RE: Woodland View Final Plat & Emergency Access Easement Review  
Village of Random Lake

##### **Sheet 1 of 2**

# Woodland View

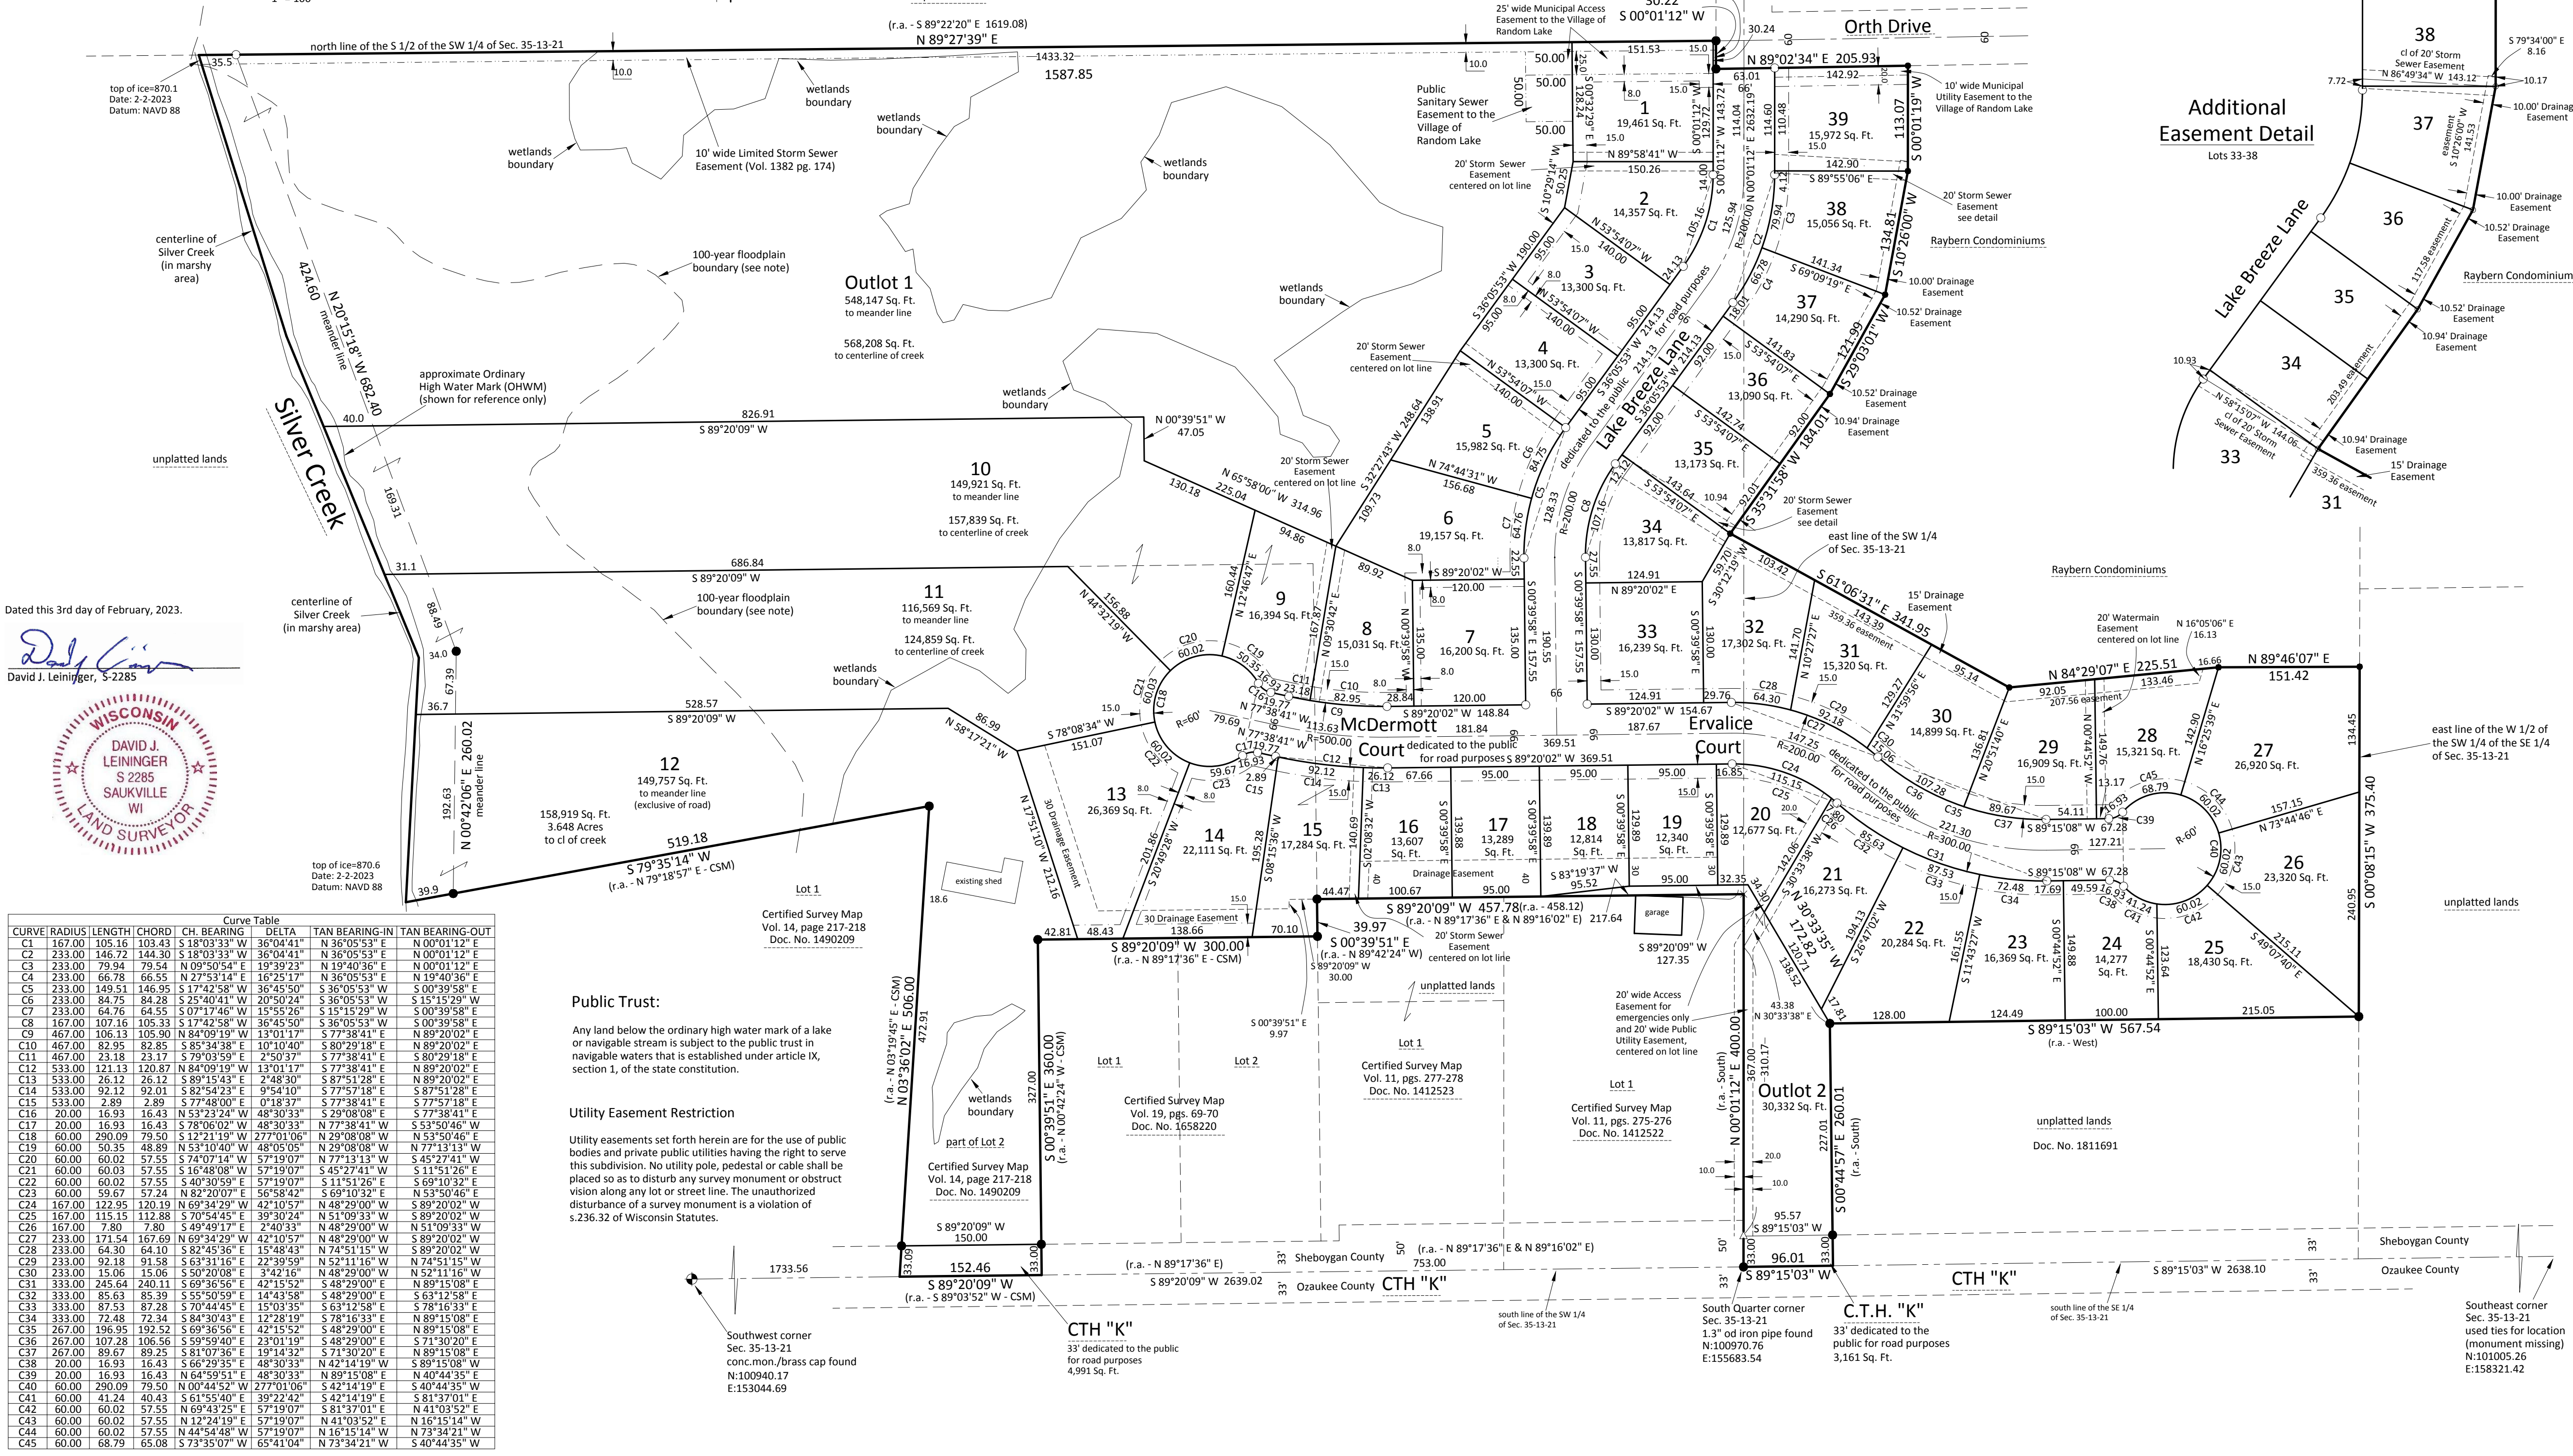
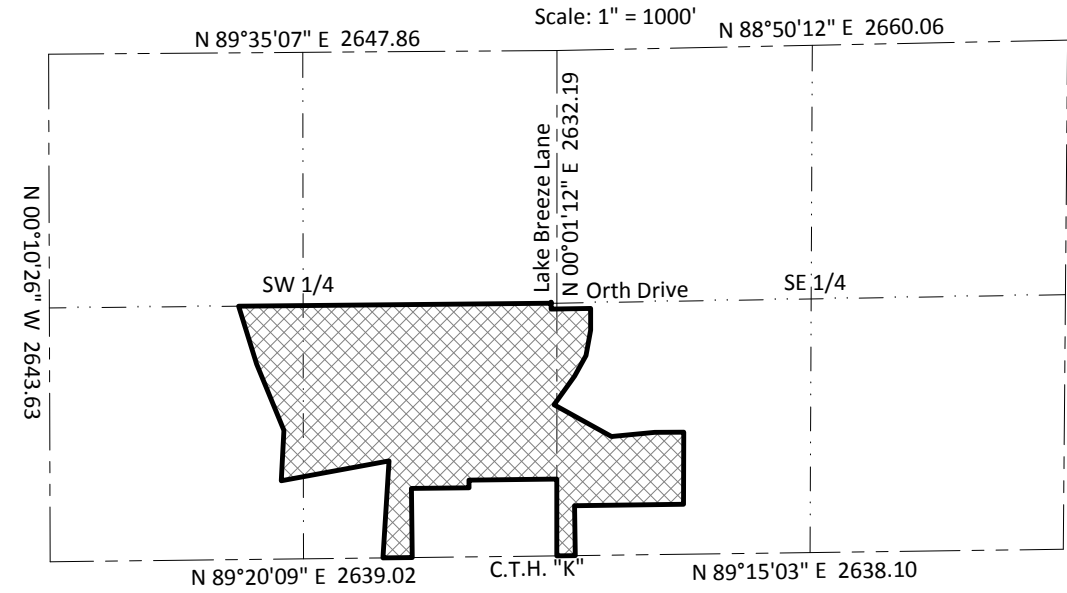
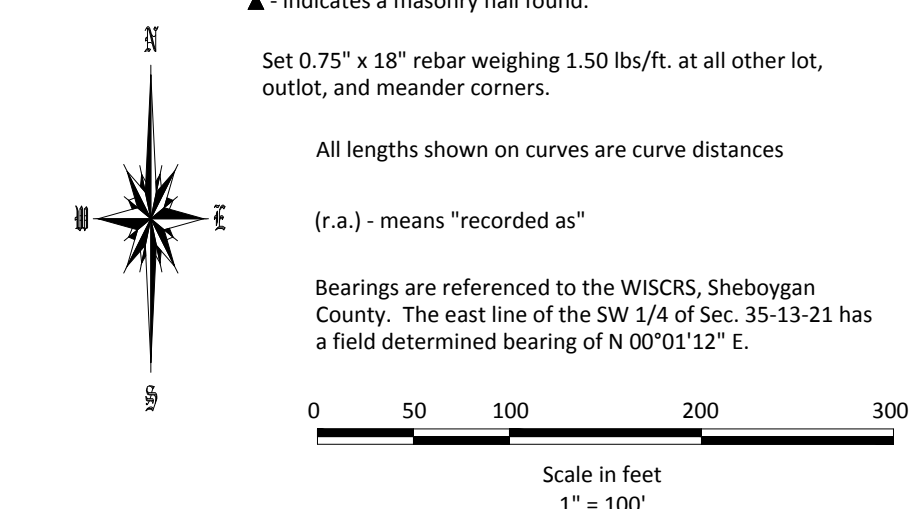
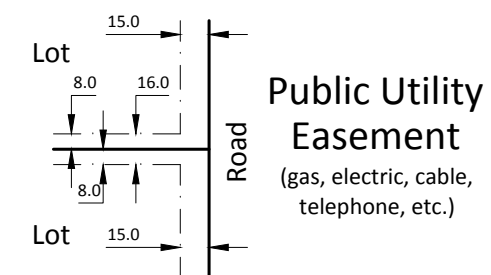
1. The 25' wide Municipal Utility Easement along the north side of Lot 1, Woodland View, should be shown as a 33' wide road dedication, extending westerly to a point 50' west of the west line of said lot 1. **Per a previous discussion, the 25' wide Municipal Access Easement will remain as shown, being south of and adjacent to the existing 10' wide Limited Storm Sewer Easement. The said 25' wide Municipal Access Easement however should be extended westerly, between said 10' wide easement and said 50' x 50' wide easement, to the west line of said 50' x 50' Public Sanitary Sewer Easement. Note: The plat currently indicates the south line of the said Public Sanitary Sewer Easement running through the middle of Lot 1. This line should be trimmed at the west line of said Lot 1. Done.**

2. The Public Sanitary Sewer Easement shown on the west side of Lot 1, Woodland View, should be shown as 50' x 50', located west of and adjacent to the west line of said Lot 1, and south of and adjacent to the south line of the road dedication noted within Comment No. 1. **Done.**

3. The scale (1"=100') as shown within the location sketch is incorrect. **Done.**

4. The reference to utility elevations within the 2<sup>nd</sup> of “Notes:” is unclear. Please clarify if there are utility elevations shown on the plat, or what they are, or simply remove said reference if none exist. **Done.**

5. The 4<sup>th</sup> note within “Notes:”, should be modified. Public utility easements (gas, electric, cable, telephone, etc.) and utility easements to the Village of Random Lake (drainage, storm sewer, sanitary sewer, etc.) should be separate and separately identified. The said easements should also be separately shown and identified within the plat map. Unless specified differently by the utility companies, public utility easements are often 12’ wide. If not previously done, verify public utility easement widths with the utility companies. **Done.**

6. The Utility Easement Restriction note should be modified. Public utility easements (gas, electric, cable, telephone, etc.) and utility easements to the Village of Random Lake (drainage, storm sewer, sanitary sewer, etc.) should be separate and separately identified. The same applies for the typical utility easement detail and note below said restriction note. Unless specified differently by the utility companies, public utility easements are often 12’ wide. If not previously done, verify public utility easement widths with the utility companies. **Done.**

7. Between Lots 19 & 20, there are dimensions for a 15’ wide easement, a 16’ wide municipal utility easement, & a 20’ wide access easement. The Village would prefer a single width of 20’ for all easement interests within this corridor. Also please clarify all easement interests. **Done.**

8. We would recommend adding a detail to visually represent the 3’ wide dedication at the SW corner of Lake Breeze Lane and Orth Drive. **Done.**
9. The total distance along the east side of Lots 25 & 26 (**now 26 & 27**), must equal the sum of the east line of said lots. **Done.**

10. We believe Plat Review will require the overall distance (143.71’) (**now 143.72’**) to be shown along the east side of Lots 1 & 2. **Done.**
11. Within the curve chart, the total distance of Curve 27, needs to equal the sum of Curves 28-30. **Done.**

12. The total distance along the south side of Lots 27 & 28, (**now 28 & 29**) must equal the sum of the south line of said lots. **Done.**
13. The total distance along the north side of Lots 22 & 23, (**now 23 & 24**) must equal the sum of the north line of said lots. **Done.**

14. Within the curve chart, the total distance of Curve 40, needs to equal the sum of Curves 41-45. **Done.**
15. Within the curve chart, the total distance of Curve 31, needs to equal the sum of Curves 32-34. **Not Modified. Done.**

16. Within the curve chart, the total distance of Curve 18, needs to equal the sum of Curves 19-23. **Done.**
17. Within the curve chart, the total distance of Curve 9, needs to equal the sum of Curves 10-11. **Within the curve chart, the Curve 10 arc length (82.96) needs to be modified to match the distance shown on the plat (82.95). Done.**

18. The Village is not requiring building setbacks to be shown on the final plat. However, if they are going to be shown they need to be identified and dimensioned. **Done.**

19. The Village corporate limits lines, as well as adjoining land owners names, do not have to be removed, but they are not required. **Done.**
20. Within the legend at the upper left of the plat, the weight per lineal foot of the 0.75" x 18" rebar needs to be indicated. **Done.**

21. A determined or approximated ordinary high-water mark needs to be shown along the creek on the west boundary of the plat, along with distances from the meander line to said ordinary high-water mark. **Done.**

22. The vertical datum needs to be noted on the face of the plat. **Done.**
23. Since Document No. 1811691, is referenced within the subdivision boundary description of the Surveyor's Certificate, we would recommend adding the location of said document to the face of the plat as well. **Done.**

## **Sheet 2 of 2**

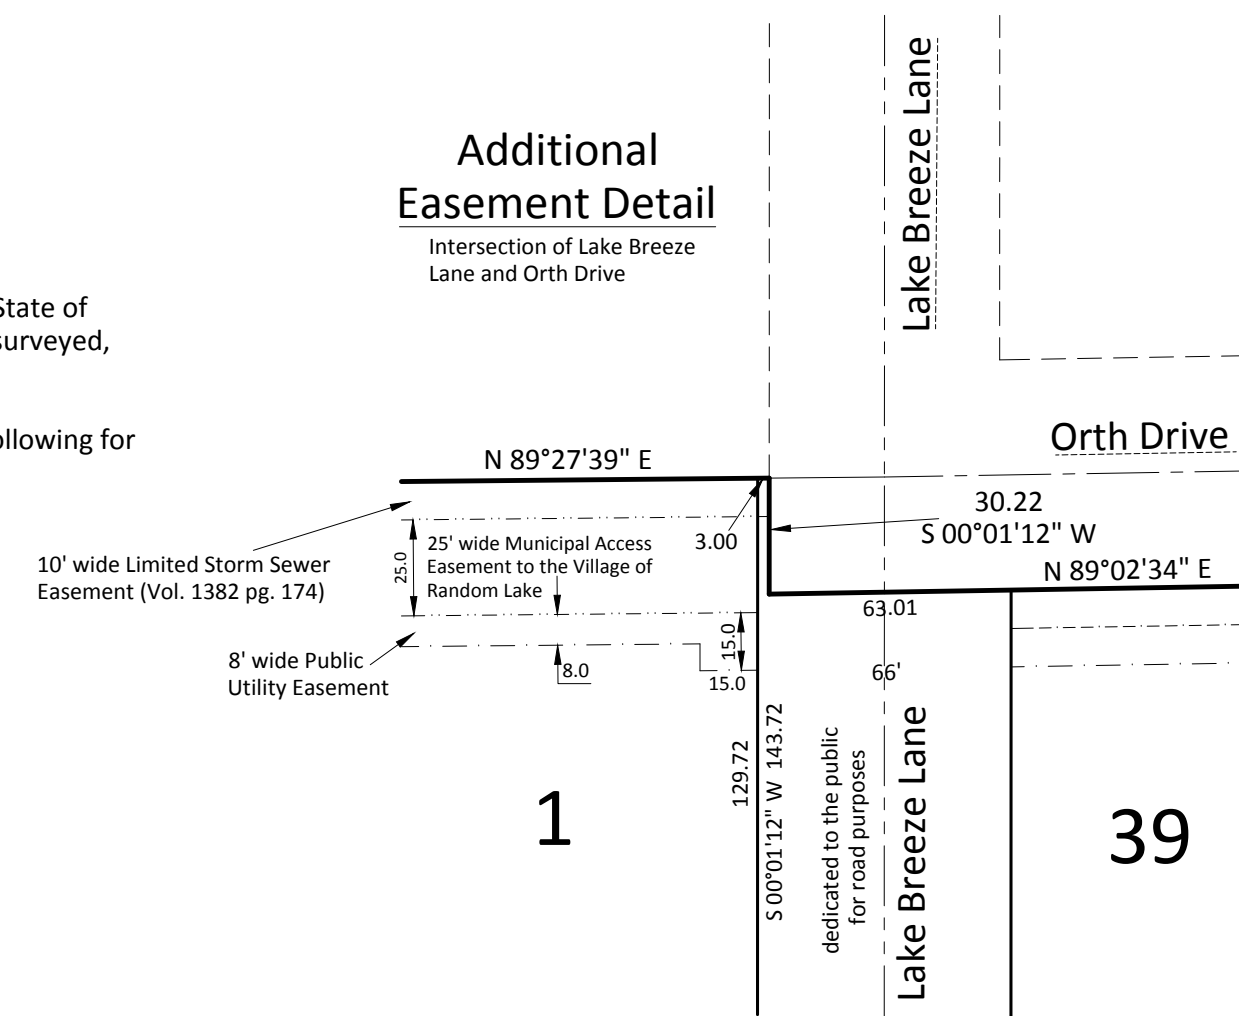
24. If there is a mortgage on the land included within the plat boundary, a mortgagee certificate will be required. **Apparently no mortgage.**
25. The developer will need to re-submit the final plat with the same boundary as shown on the preliminary plat submitted. The (2) proposed CSM areas removed from the preliminary plat need to be added back into the final plat boundary as well as the south boundary line along Lots 15-20, and any other revisions to the boundary between the preliminary and final plat. This is necessary to guarantee that final plat boundary follows the TID 4 boundary description. **Done.**
